Theme: Oxydated fuse

Theme area Electrical Telephone +49 (0)40/ 739 606 – 42

Version 02/2010 Date: 11.02.2010

Photo 2:

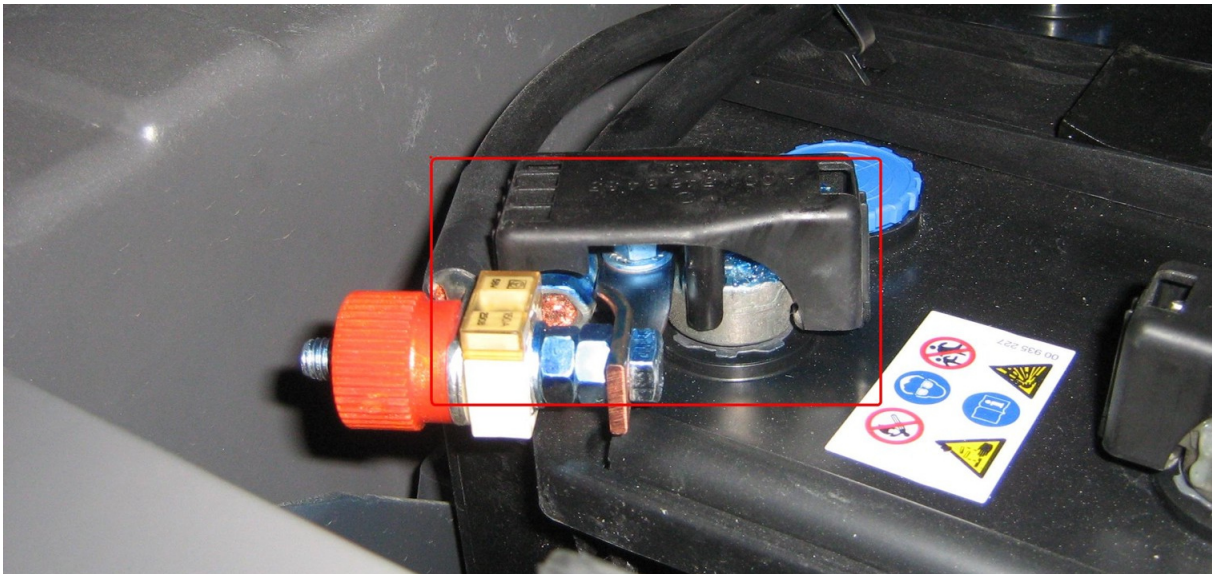
Battery cable / tail-lift fuse is not secured enough against splashing water

In order to avoid failure, we suggest following steps:

Loosen the battery plus clamp, remove the copper bridge
Cut the red cable (16 mm²) about 100 mm behind the cable socket

Remove about 10-15 mm of the cable protection at its end

Squeeze the cable socket open
Screw on the fuse

Position the shrink hose in the middle over the fuse
Shrink the hose with a hot air pistol
Screw the cable socket directly onto the battery clamp
